RE: Parker Ridge (FSP-24-20)
Major Subdivision Final Plat – Submittal #2

The enclosed plat was revised according to 1st review comments received on December 9, 2024. Please find the following responses to the comments provided on the Town’s website.

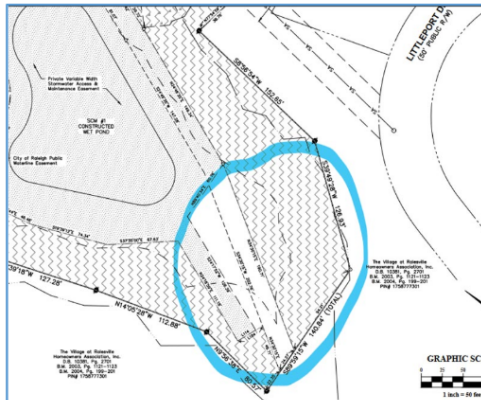
Comment #5: Revise this entire wetland area where the future Greenway boardwalk will be built by the Town as a Greenway easement to provide the Town with the ability to work with any environmental constraints that we may encounter upon construction. See clip.

Response #5: The plat has been revised accordingly.
